Re: Objection to The Timberyards Rental Housing Project at multiple lots bound by Victoria Road, Sydenham Road, Farr Street and Mitchell Street, Marrickville – SSD-76927247

This objection has been prepared by Mecone Group (Mecone) on behalf of a landowner group in relation to SSD-76927247 for The Timberyards rental housing project, comprising built to rent housing (BTR), co-living housing, in-fill affordable housing, commercial premises and public and private recreation area at multiple lots bound by Victoria Road, Sydenham Road, Farr Street and Mitchell Street, Marrickville.

Figure 1 Non-compliant building separation

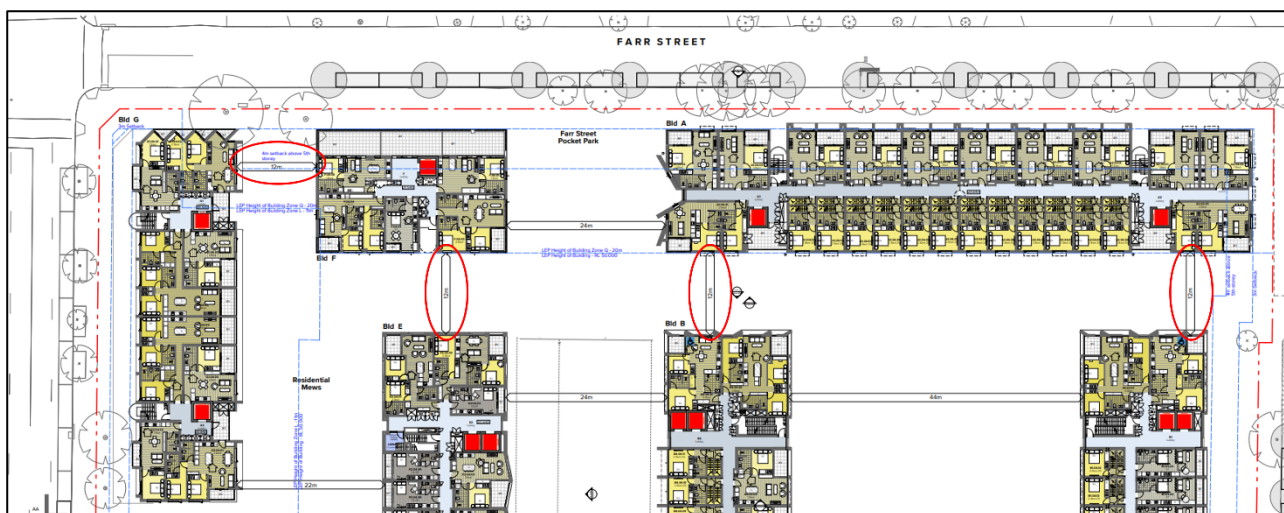
The proposal exhibits non-compliances with the above separation requirements. Specifically, the non-compliances exist between Building B and A, Building F and E and Building G and F (see **Figure 1** below). As these buildings are eight storeys and above, a building separation of at least 18m is required between these buildings. However only 12m separation has been provided in the proposal. These buildings are also located directly adjacent to each other, which poses significant visual privacy concerns. We note this was also raised by the State Design Review Panel (SDRP) during consultation however the insufficient separation has been maintained for these buildings, undermining the residential amenity of the affected apartments.

Figure 2 MDCP2011 Movement Network Map

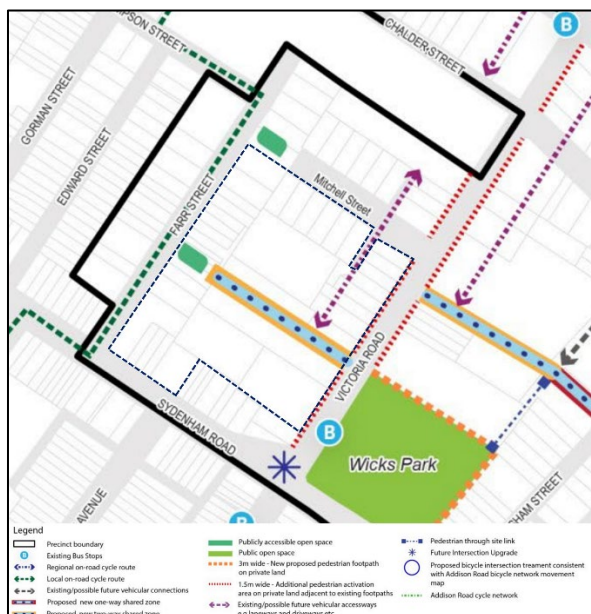
The proposal comprises three vehicular access points, being a retail/service access on Mitchell Street and two access points on Farr Street for residential access and a shared area access for small deliveries respectively. The proposed access arrangement is inconsistent with Section 9.47.7 of MDCP 2011.

Specifically, under the Movement Network Map, no vehicular access points are envisaged for Farr Street. Rather, vehicular access is to be facilitated via Mitchell Street and a new two-way shared zone accessed from Victoria Road. Nevertheless, the proposal seeks to utilise Mitchell Street for retail/service vehicle access only and utilise Farr Street for both small deliveries and residential access, in which the basement carpark has capacity for 238 residential parking spaces. This is inconsistent with the indicative movement network for Precinct 47 as well as Control C12 which requires the number of vehicle entry points per block to be minimised and located to maximise visual amenity within the public domain. Given Farr Street is a local road only, the provision of two access points on Farr Street would significantly increase the traffic on the street and worsens the surrounding road network, particularly when the residential access is provided on Farr Street, which is the main generator of traffic from the proposal.

That all vehicular access points currently proposed along Farr Street be relocated. Farr Street is a narrow local road that functions as a key pedestrian route to Marrickville Public School, including for children and families during peak drop-off and pick-up periods. The location of high-volume access points on this street presents unacceptable safety and congestion risks and is inconsistent with the DCP's movement network.
